STATE OF MICHIGAN  
IN THE WASHTNAW COUNTY CIRCUIT COURT

Case No. 88-34734-CE  
Hon. Timothy P. Connors

**INTERVENORS' EXPERT REPORT**

## **Scientific/Technical Expert Report**

**Figure 1.** Proposed monitoring well spacing along northern perimeter of the Eastern Area Prohibition Zone.

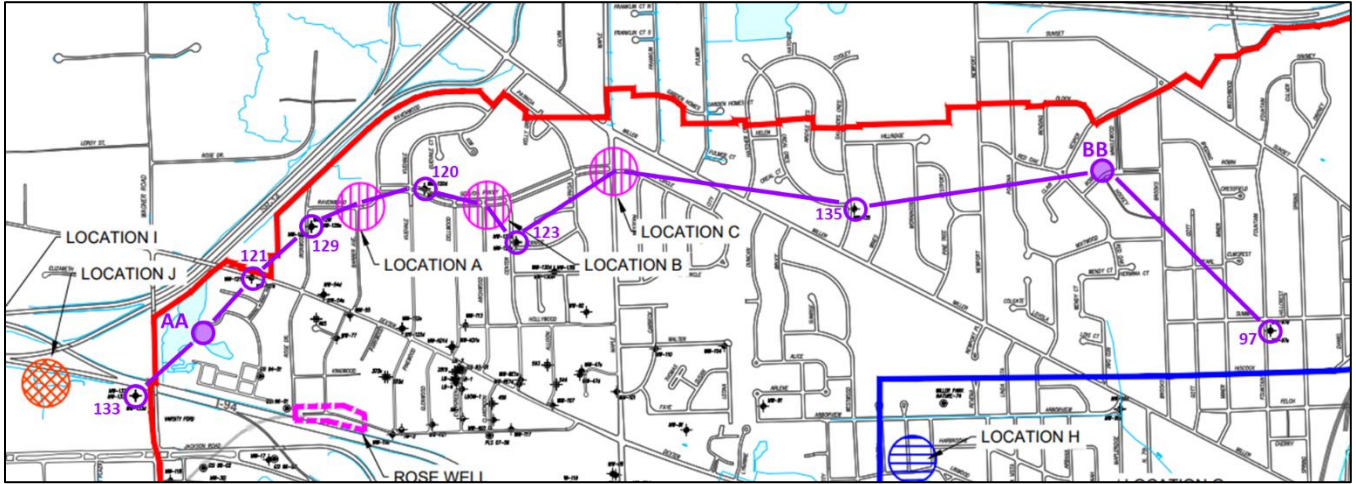
- A Sentinel Well (AA) closing the gap between MW-133 and MW-121
- A Sentinel Well (BB) near the northeast Prohibition Zone boundary between MW-135 and MW-97
- A replacement well (CC) in the vicinity of the former MW-63 well cluster

The first well (AA) reduces the spacing between MW-133 and MW-121 from 2,000 feet to 1,100 and 900 feet (**Table 1, Figure 1**). The second well (BB) reduces the spacing between MW-135 and MW-97 from 5,100 to 3,000 and 2,700 feet (**Table 1, Figure 1**). The third well (CC) replaces MW-63 (**Figure 2**).

Proposed sentinel well AA will fill a perimeter gap in a sensitive area southeast of Elizabeth Road, where 1,4-dioxane has been detected in residential drinking water wells. Proposed sentinel well BB will fill the largest gap along the northern perimeter of the Prohibition Zone. Proposed monitoring well CC will replace MW-63, formerly the farthest southwest point in the Western Area monitoring well network. The need to install additional perimeter monitoring wells in strategic positions may become apparent after the results of the new wells proposed here and in the Proposed 4<sup>th</sup> CJ are analyzed.

**Figure 4.** Proposed alternative Prohibition Zone expansion. Blue shaded areas represent Intervenor proposed expansion. Green shaded areas show the larger extent of the expanded Prohibition Zone in the Proposed 4<sup>th</sup> CJ.

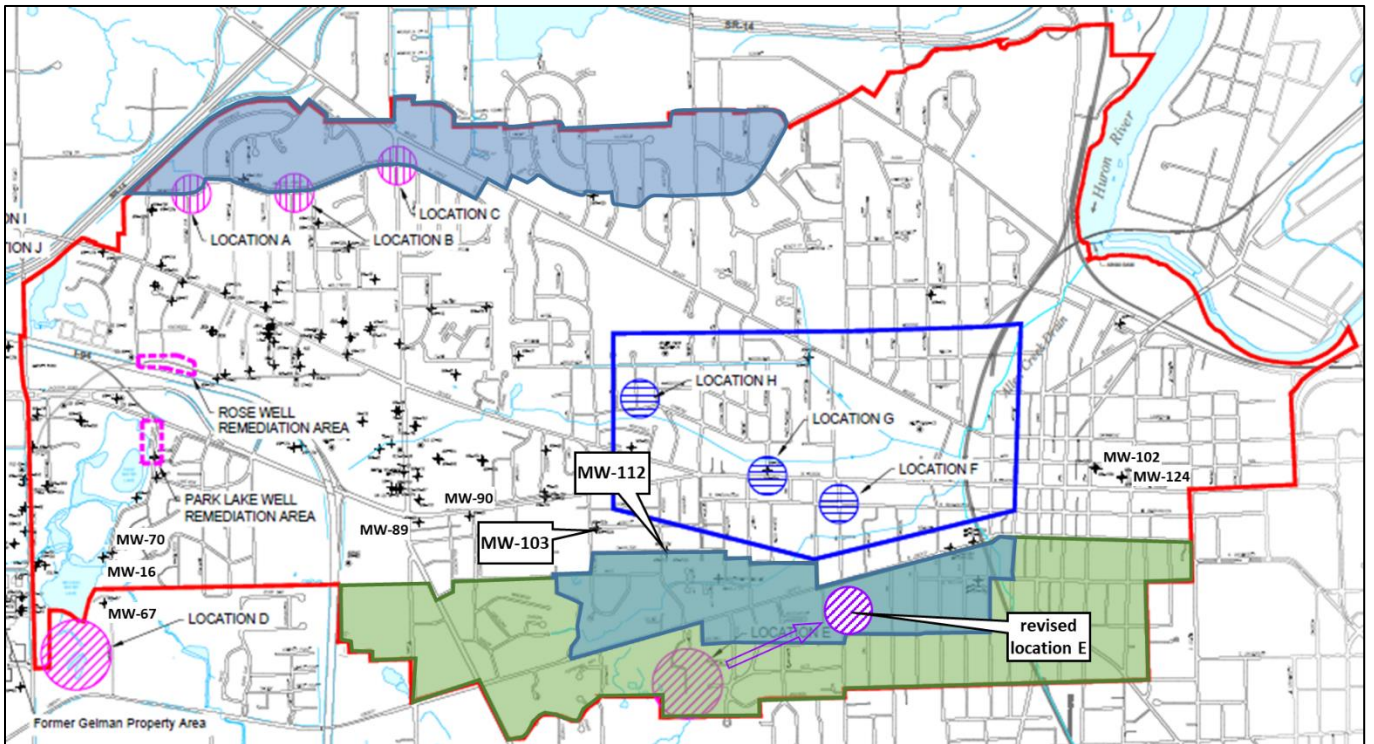
As an alternative to the Prohibition Zone expansion included in the Proposed 4<sup>th</sup> CJ, the Intervenor's propose a more limited increase in the Prohibition Zone as shown on **Figure 4**. This modification accepts the entirety of the proposed expansion to the north, but limits Prohibition Zone expansion to the south to the area downgradient of monitoring well MW -112, which is situated on the current southern Prohibition Zone boundary, because MW-112i has seen 1,4-dioxane concentrations in the 9 to 11 ppb range since 2014 (**Figure 5**). Repositioning the proposed Boundary Well at location E to a more advantageous location, as shown on **Figure 4**, is also recommended by the Intervenor.

**Scientific Rationale.** A smaller, more limited Prohibition Zone expansion to the south is justified by the relatively steep concentration gradient along the southern edge of the plume. Less than 400 feet of separation between the 85 and 7.2 ppb concentration lines suggests that 400 feet or less of additional buffer are needed to accommodate the drinking water standard reduction to 7.2 ppb. With the exception of MW-103 and MW-112, monitoring wells near the current southern Prohibition Zone boundary (MW-16, MW-67, MW-70, MW-89, MW-90, MW-102, and MW-124) have concentrations below 7.2 ppb. Concentrations above 7.2 ppb observed in MW-103 and MW-112i justify additional expansion south and east of these wells, as shown in **Figure 4**.

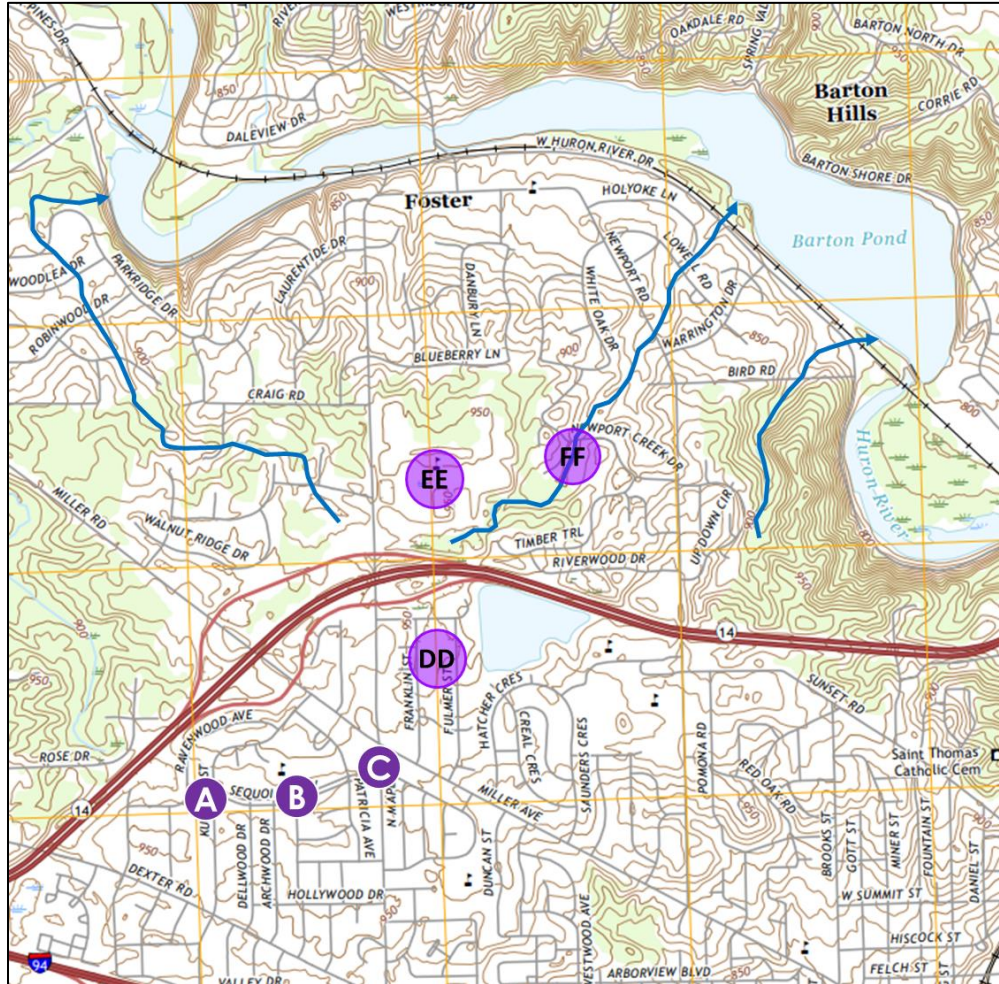
Because the potential consequences of 1,4-dioxane in the groundwater plume reaching Barton Pond are enormous, the Intervenor seeks three additional monitoring wells north of the prohibition zone in the vicinity of M-14 and Skyline High School (wells DD, EE, and FF on **Figure 6**). The purpose of these wells is to:

- a. determine the presence or absence of aquifer material between the Prohibition Zone and Barton Pond;
- b. measure static water level elevations to determine if a groundwater divide is present and ascertain the direction of groundwater flow in this area; and
- c. although it is not expected, determine whether 1,4-dioxane is present north of the Prohibition Zone.

**Figure 10.** Locations of Allen Creek South Branch sampling points and proposed high-resolution transects.

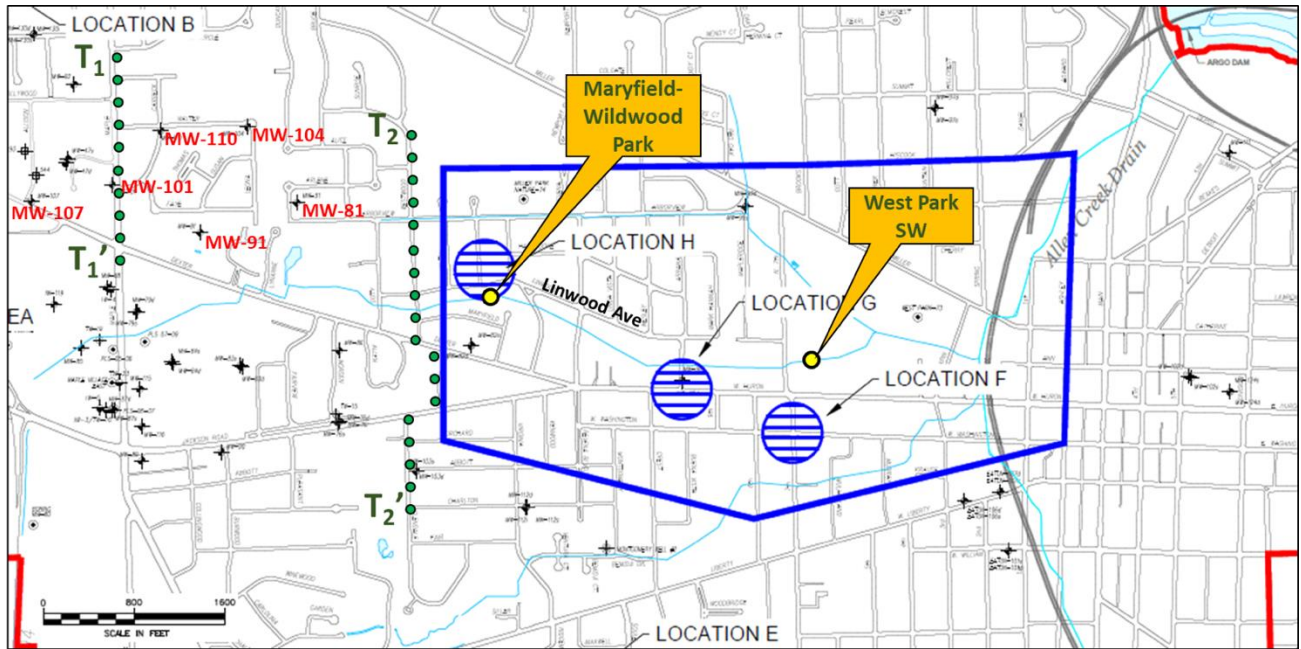
The purpose of high-resolution profiles or ‘transects’ in the Eastern Area of the Gelman Site is to characterize the presence or absence of dioxane at concentrations above GSI migrating at all depths above bedrock at the present time. Temporary boreholes in each transect should be placed at a 200-foot minimum lateral spacing and water samples should be taken at 10-foot vertical increments to establish a concentration profile at each borehole location. Results can be used to position permanent monitoring wells in zones of highest observed concentrations, quantify contaminant mass flux across each transect, and to guide additional downgradient investigation (Sections 2B and 2C). Two north-south profiles (perpendicular to the primary direction of groundwater flow) are needed (**Figure 10**):

The Maple Road profile ( $T_1-T_1'$ ) will identify preferential flow pathways and maximum 1,4-dioxane concentrations crossing Maple Road downgradient of monitoring well MW-107. Concentrations in MW-107 rose to 700 ppb or more beginning in 2014 and have remained at similar levels since then (**Figure 11**). Unfortunately, the network of monitoring wells downgradient from MW-107 (**Figure 10**) are screened at elevations 20 to 75 feet *deeper* than MW-107 (**Table 2**), making it unlikely that they will detect dioxane as it migrates upward through the aquifer system east of Maple Road. Identification of preferential flow pathways conveying groundwater with elevated dioxane concentrations along transect  $T_1-T_1'$  will inform the process of installing monitoring wells to better delineate the extent of 280 ppb in the downgradient area north of the South Branch of the Allen Creek Drain (Section 2B).

The Glendale-Grandview-Westwood profile ( $T_2-T_2'$ ) will identify preferential flow pathways and maximum 1,4-dioxane concentrations immediately upgradient of the Allen Creek Drain segment that is receiving dioxane from venting groundwater (**Figures 9 and 10**). Information from this transect will therefore also help determine effective locations for monitoring wells needed to further delineate the extent of 280 ppb in the downgradient area (Section 2B) and, in addition, guide the design of shallow groundwater profiling on the north and south sides of the Allen Creek Drain (Section 2C).

In the vicinity of MW-82s, it is unclear whether to expect higher concentrations north or south of MW-82s (Section 2B). Transect T<sub>2</sub>-T<sub>2</sub>' will therefore help optimize positioning of the monitoring well at location H on the north or south side of the Allen Creek Drain (**Figure 10**).

**Figure 14.** Proposed locations of downgradient monitoring wells GG and HH and approximate area of artesian groundwater conditions.

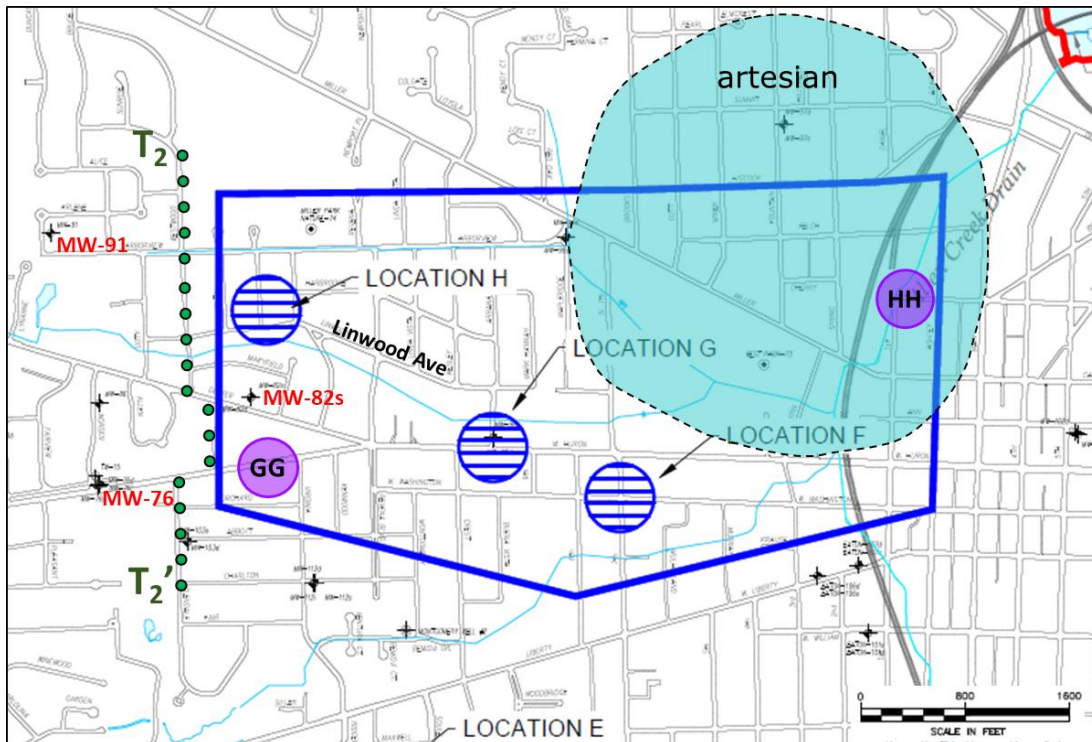
Instead of the leading edge of the center-line of a broad, diffuse plume, the Intervenor maintains that MW-82s represents lateral dispersion (like MW-76s or MW-91) from one or more unrecognized higher concentration fingers of dioxane migrating north or south of MW-82. This alternate interpretation cannot be ruled out by the current, widely-spaced monitoring well network and would only be partially evaluated by well locations F, G, and H (**Figure 14**) in the Proposed 4<sup>th</sup> CJ. Moreover, the Intervenor's alternate interpretation is supported by the high concentrations of dioxane observed at Allen Creek – West Park SW. Consequently, two additional monitoring wells are needed in the downgradient investigation at locations GG and HH as shown on **Figure 14**.

**Scientific Rationale.** The proposed monitoring well at location GG on the south side of MW-82s will complement the proposed well at location H on the north side of MW-82s (**Figure 14**). Both of these locations can be optimized based on the results of transect T<sub>2</sub>-T<sub>2</sub>'. Monitoring wells at locations GG and H will determine if higher concentrations of 1,4-dioxane are flanking MW-82s. An additional proposed monitoring well at location HH in the Allen Creek surface drainage way will investigate the potential for 1,4-dioxane at concentrations above GSI along the expected migration pathway through a loosely defined area of artesian groundwater conditions conducive to additional venting to the Allen Creek Drain or the creation of shallow groundwater conditions at elevations close to residential basements in this area. Together, monitoring wells at proposed locations GG and HH will help to ensure that the Eastern Area "Groundwater Surface Water Interface Objective" in the Proposed 4<sup>th</sup> CJ is met.

**Figure 15.** Proposed location of monitoring points (solid black dots) between the Maryfield-Wildwood Park and West Park SW sampling locations along the South Branch of the Allen Creek Drain.

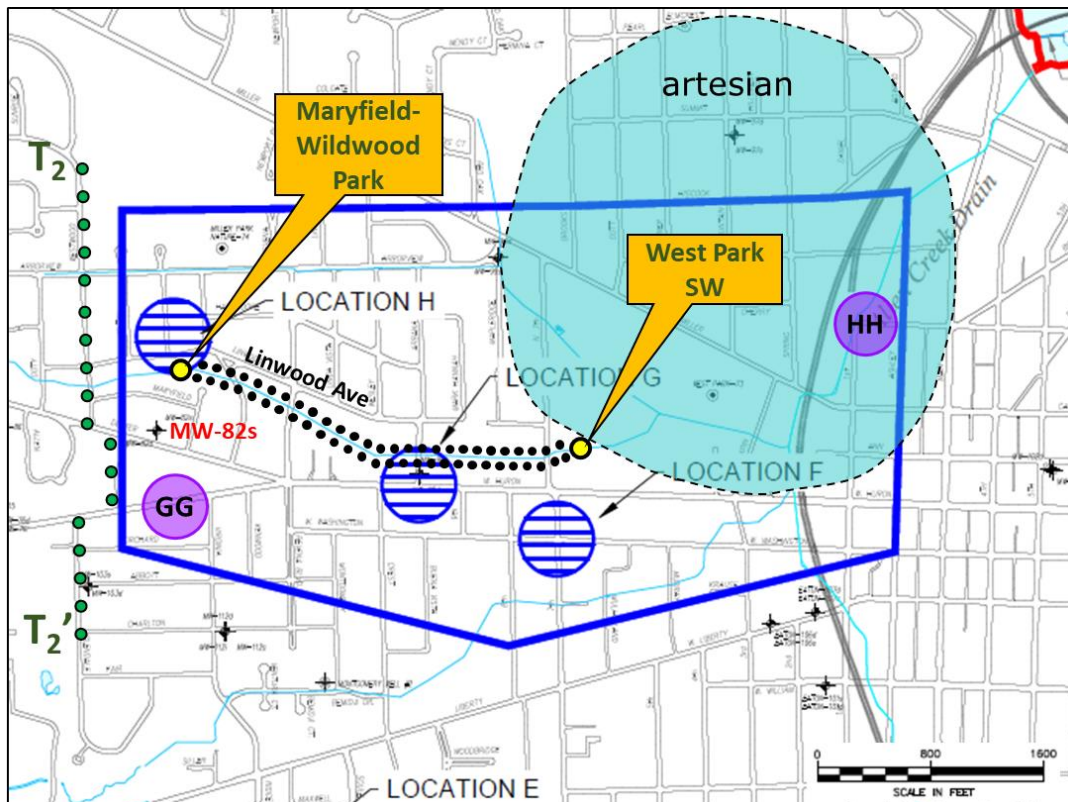
The Intervenor proposes a high-resolution profiling survey along the edges of the South Branch of the Allen Creek Drain, parallel to Linwood Avenue (**Figure 15**). Samples of groundwater should be collected from both sides of and closely adjacent to the Drain using direct push or percussive methods. Profiling should take place at a lateral spacing of 100 feet or less between points and discrete samples should be collected beginning at first groundwater and every five feet thereafter until a minimum depth of 10 feet below the drain level is reached. Profiles should be completed on the north and south sides of the Drain unless the high-resolution transects (Section 2A) and downgradient delineation wells (Section 2B) demonstrate to EGLE's satisfaction that contaminated groundwater at concentrations greater than the GSI is not present north or south of this portion of the Allen Creek Drain.

Results of the shallow groundwater profiling should be used to install a minimum of three shallow groundwater monitoring well nests along each side of the Allen Creek Drain where the presence of groundwater at or above GSI concentrations has been delineated. Each monitoring well nest location should include at least two monitoring wells screened at the equivalent depth of the drain and 5 feet deeper so that a vertical hydraulic gradient can be determined.

**Figure 18.** Source treatment areas and proposed extraction wells on the Gelman Property. Adapted from Attachment I of the Proposed 4<sup>th</sup> CJ.

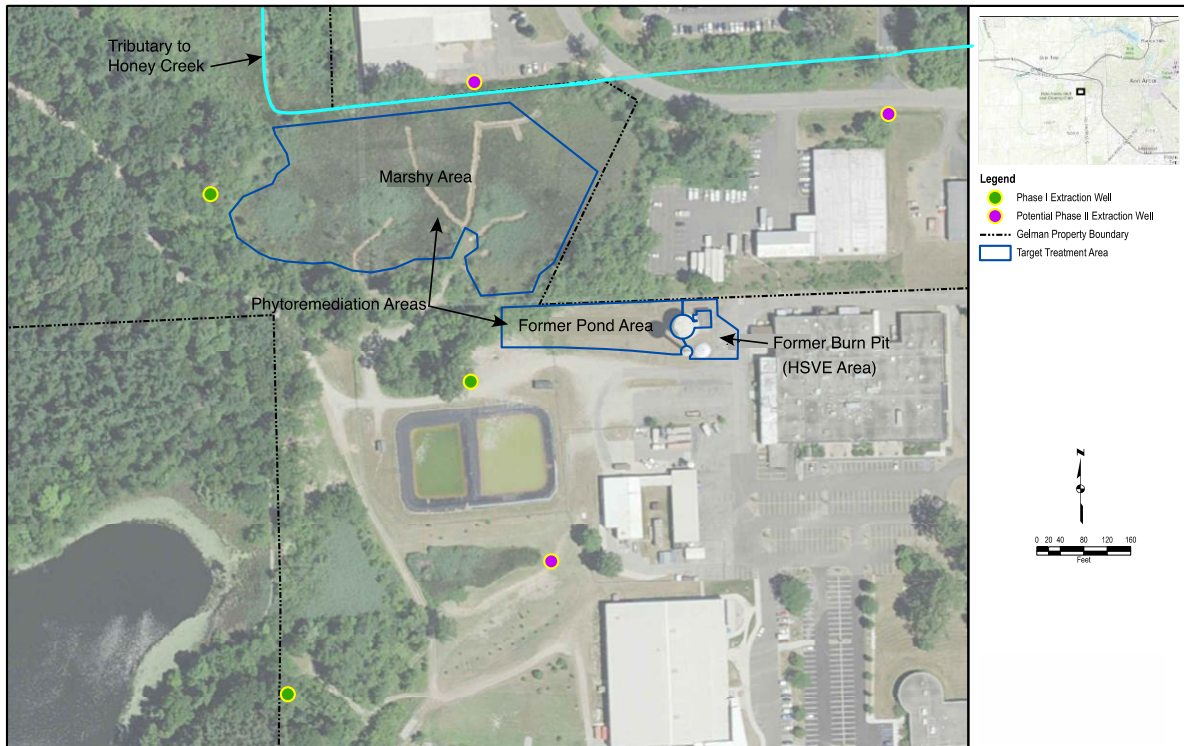
The benefit of mass removal in the source area has been repeatedly demonstrated. Data collected from extraction wells located in and near the source area indicate that significant removal takes place over a two-to-four-year period following installation before diminishing returns in the form of asymptotically lower concentrations follow. The three initial recovery wells in the Proposed 4<sup>th</sup> CJ are positioned in the northwestern, central, and southwestern portion of the source area, whereas the three contingent additional wells are positioned in the northern, eastern, and southeastern portion of the source area (Figure 18).

**Scientific Rationale.** The intervenors propose that all six proposed wells be installed and operated in the source area as quickly as possible, with a collective extraction rate of 150 gpm or more. In the Marshy Area in particular, aquifer heterogeneity is compounded by the presence of organic rich peat layers that impede groundwater flow in response to pumping (PGSI, 2000). Therefore, the spacing of the original three extraction wells is likely insufficient to affect groundwater flows over the entire targeted region, regardless of their initial performance removing contaminant mass.

The Proposed 4<sup>th</sup> CJ requires that Gelman perform phytoremediation for Former Ponds 1 and 2 as well as the Marshy Area of the site (**Figure 18**). The Intervenor have not seen or reviewed the investigation reports and feasibility studies that led to the selection of phytoremediation as a viable method to both reduce 1,4-dioxane mass in groundwater and to lower the groundwater table to reduce infiltration and mobilization of contaminants. Review of the existing Gelman reports pertaining to phytoremediation is essential to understanding and monitoring cleanup objectives.
